City of Mason
Planning Commission
Staff Report

TO: Planning Commission
FROM: Elizabeth A. Hude, AICP, Community Development Director
SUBJECT: 200 E. Kipp - Gestamp
DATE: August 19, 2021 for August 25, 2021 mtg - FINAL

Alan Boyer, LSG Engineers & Surveyors, on behalf of Gestamp Mason, LLC has submitted a request for approval of a Special Use Permit and Final Site Plan for construction of a new 49,200 sq. ft. addition on an existing 624,780 sq. ft. building to be used as a Finish Goods Product Storage (Low Bay) and to perform other related site improvements on property located at 200 E. Kipp Rd, parcel 33-19-10-16-100-024. The parcel is zoned M-2 General Manufacturing District.

The applicant has submitted revised drawings to address comments and requests for additional information as noted in the August 10, 2021 Planning Commission packet. The revised documents were received Monday, August 16, 2021 and include:

FILE	L1-C.DWG
DESIGNED BY	ADB
DRAWN BY	AJJ
CHECKED BY	ADB
DATE	MAY 24, 2021
SCALE	HOR. 1"=100'
VERT. 1"=100'	
PROJECT NO.	2679
SHEET NO.	L1.0

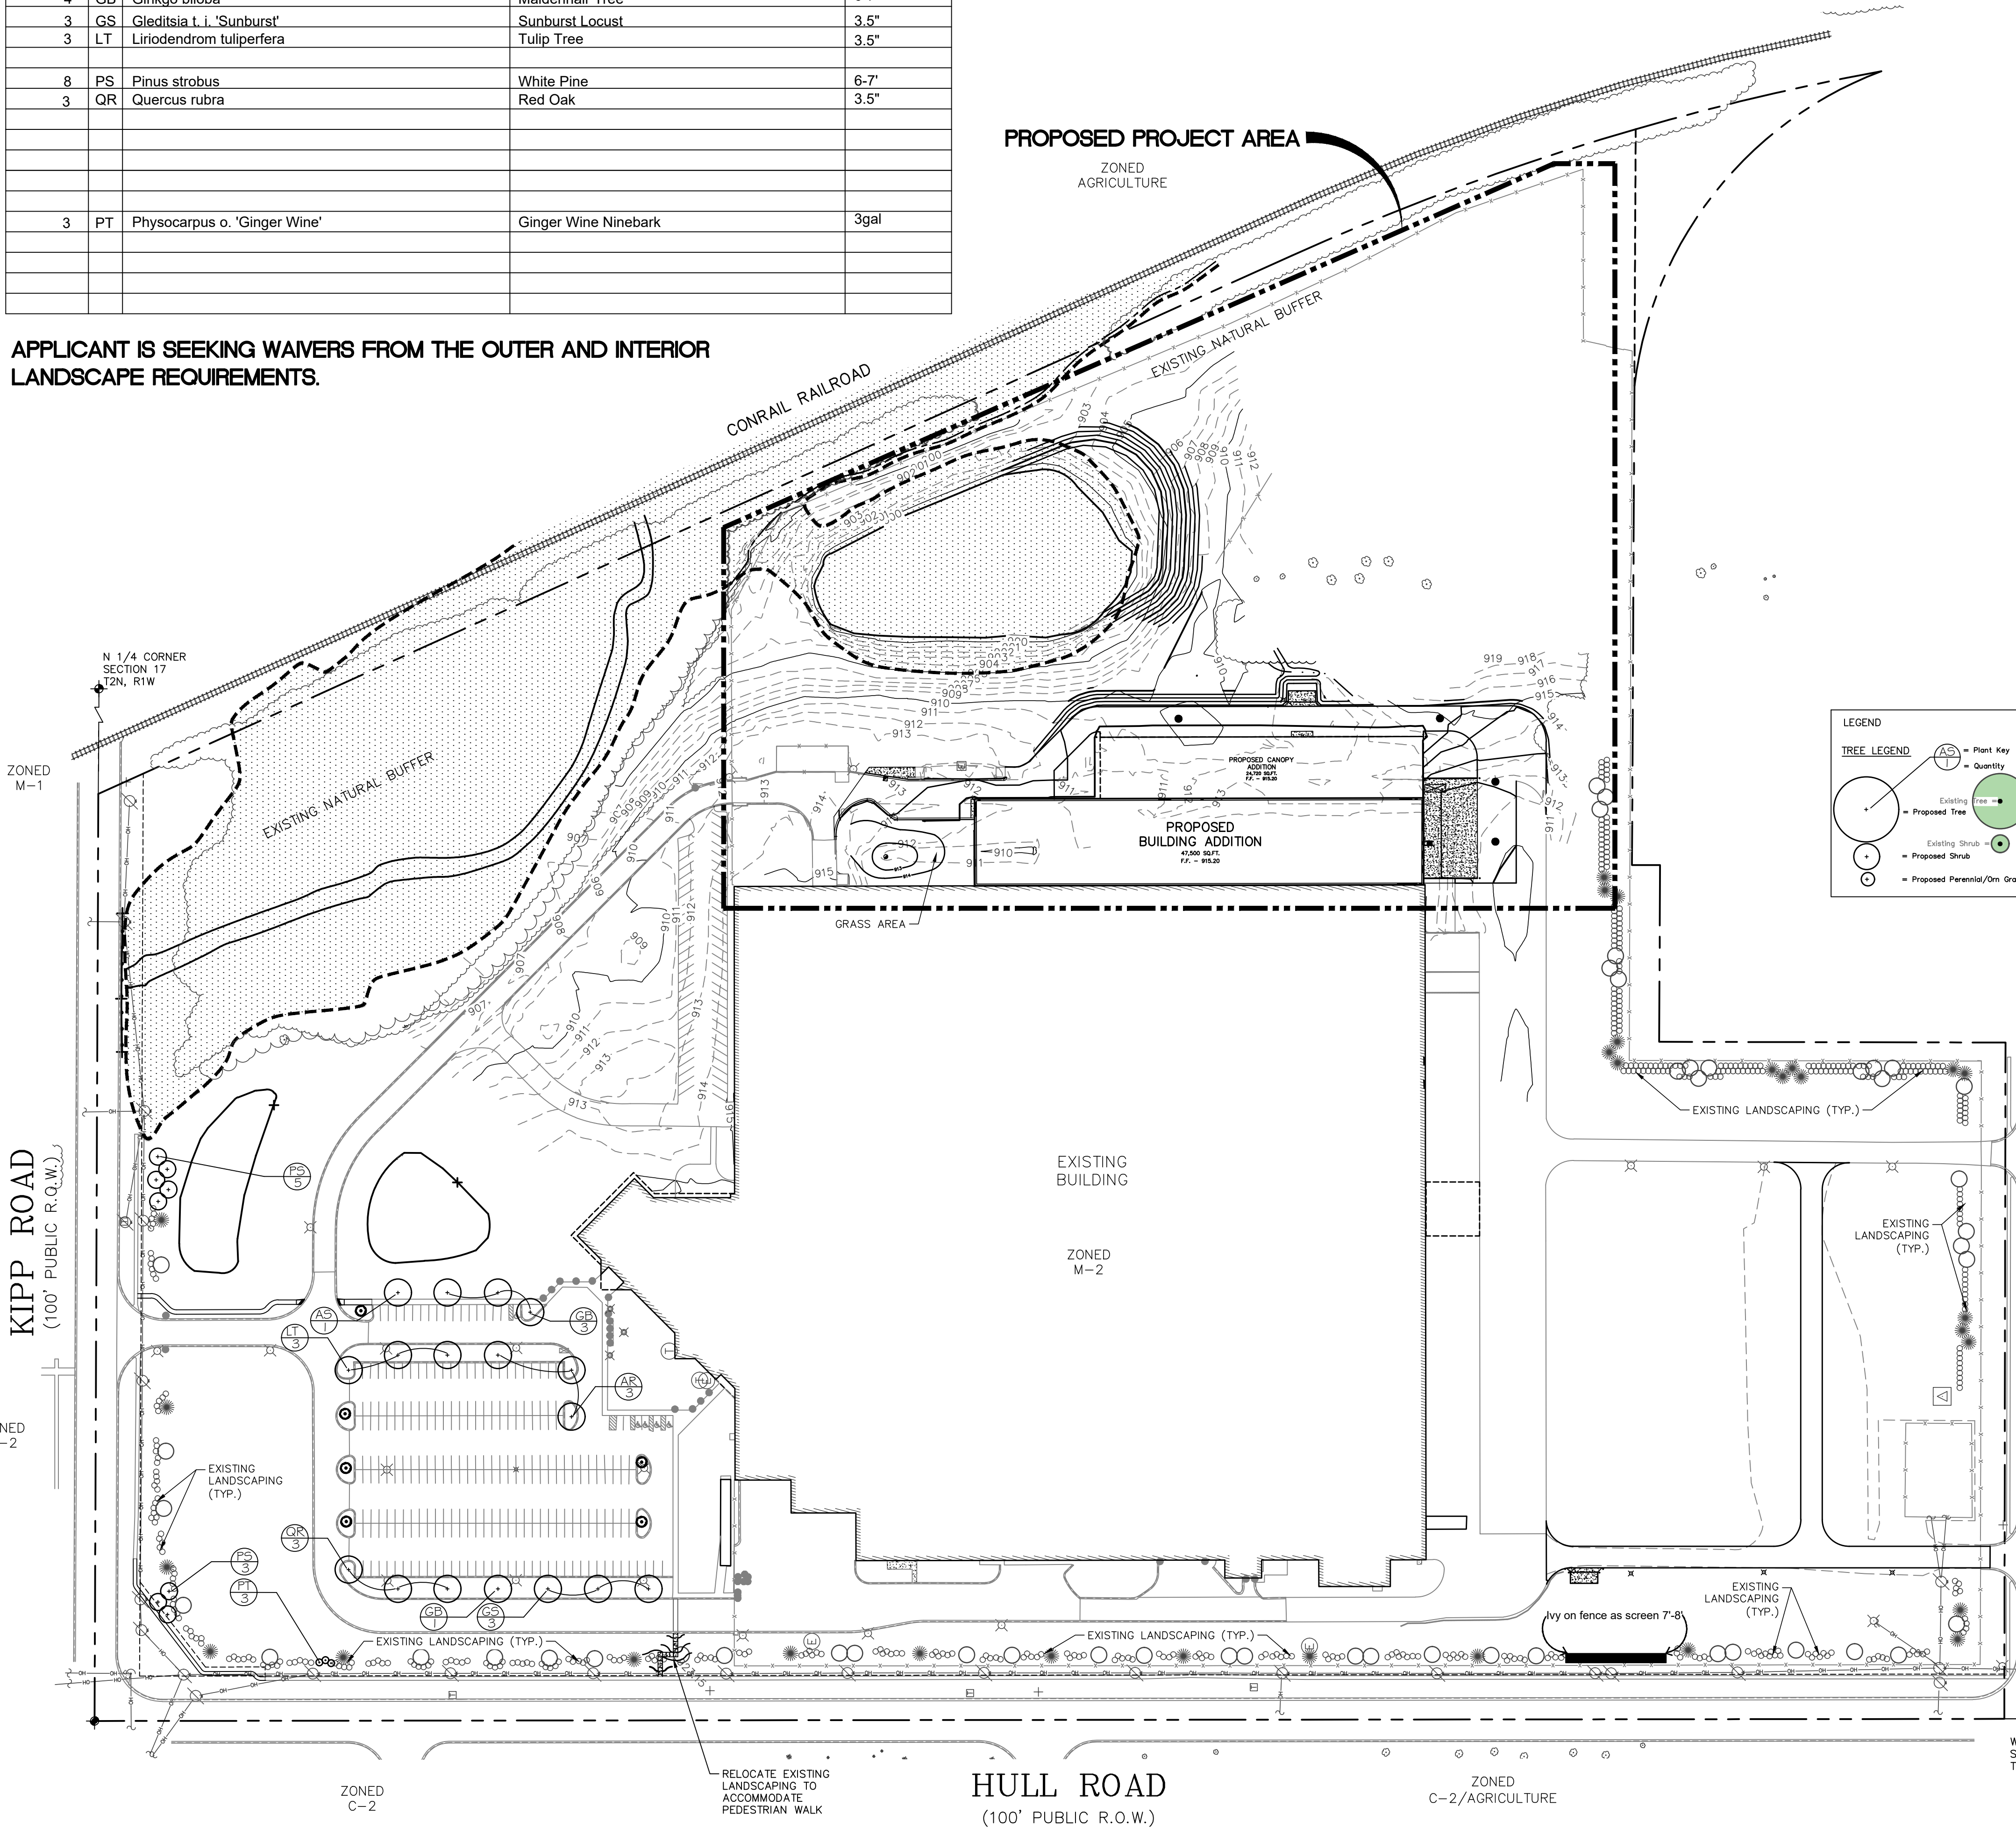
D/R	Sec. 94-241 Landscape, screening and buffer requirements
<i>The applicant has requested waivers from the landscaping requirements as shown on Sheet L1.0. The Planning Commission may choose to waive the requirements as requested so long as the intent to provide landscaping within parking areas, and to enhance aesthetic and ecological qualities, character, privacy, and land value is met. The Planning Commission has the option to accept the proposed plan and waive the requirements for the landscaping pursuant to Section 94-241 (e)(6), or require the plan to be revised with the required vegetation. Due to the significant natural buffer to the east, the berm on the west, and the proposed addition of trees around the pre-existing parking area where no changes to parking are proposed, staff recommends granting the waivers.</i>	
M	Chapter 58 - Signs
<i>No new or expanded freestanding sign is proposed. Any proposed signage will require a separate building permit subject to the requirements of Chapter 58 of the Zoning Ordinance, including Division 2 of said chapter.</i>

SHEET
E2.0

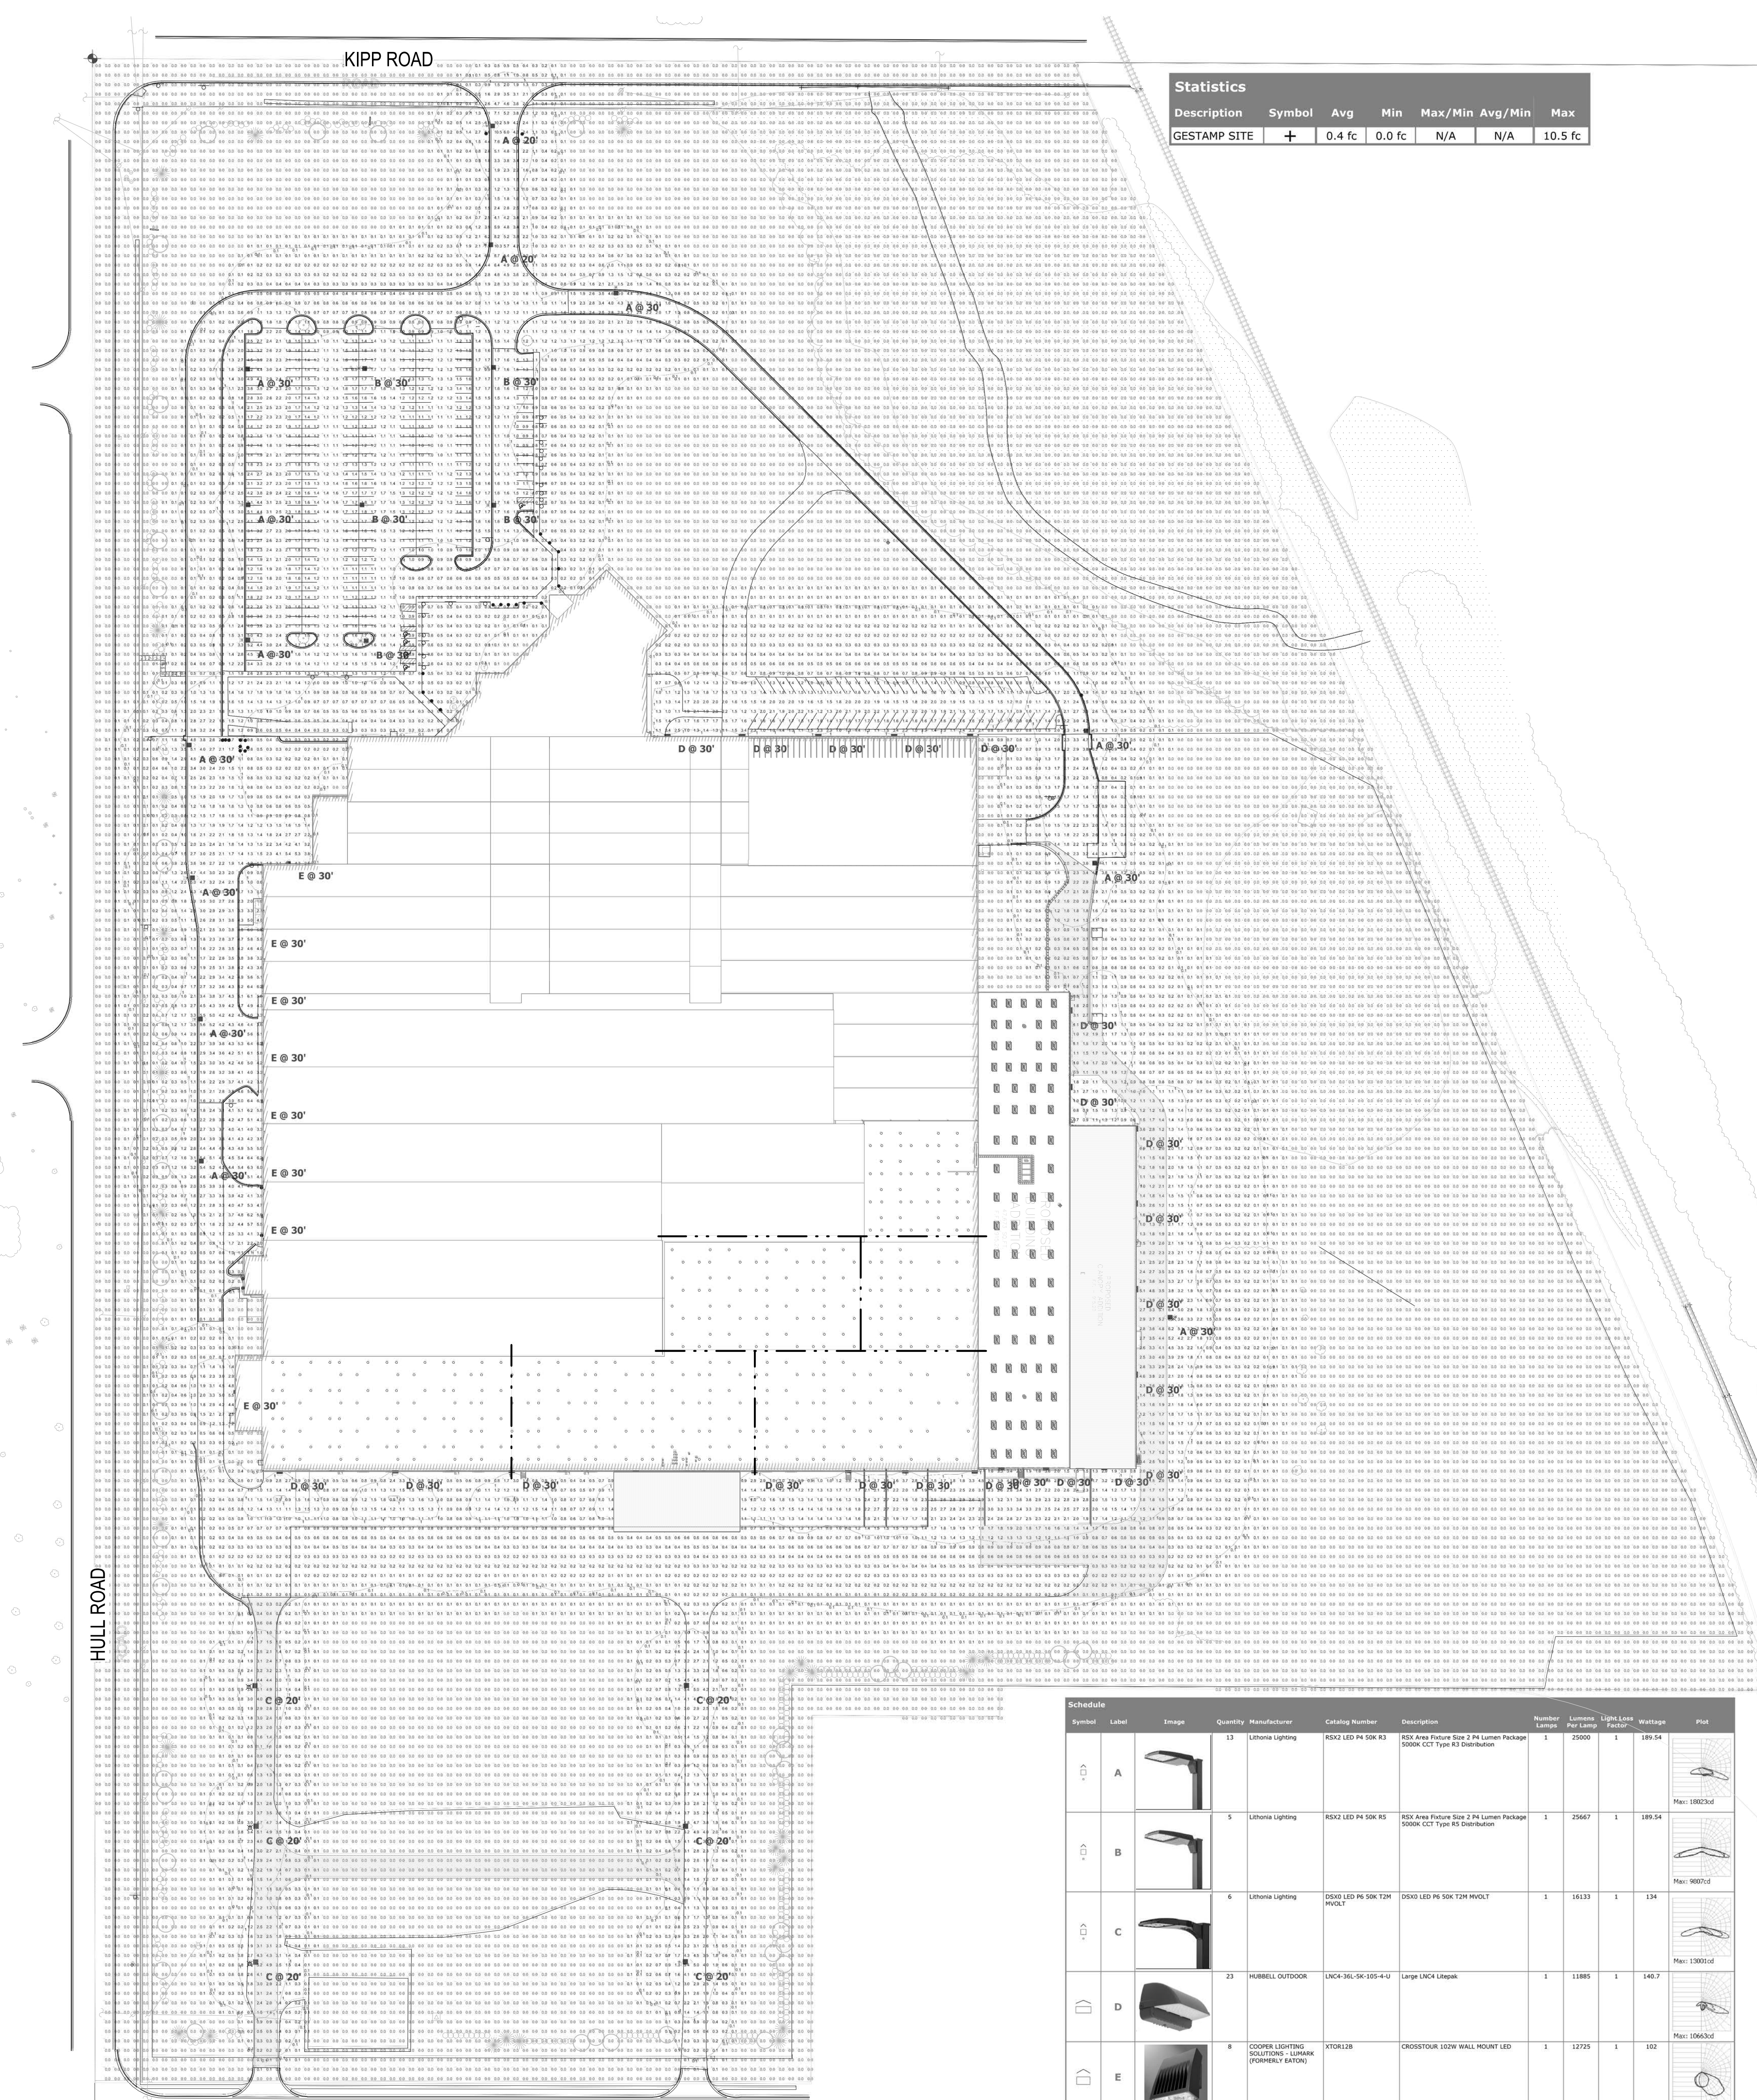
<i>A photometric plan demonstrating that site lighting be consistent with the lighting requirements listed in Section 94-177(e) of the zoning ordinance has been provided on Sheet E2.0 and appears to meet this requirement.</i>
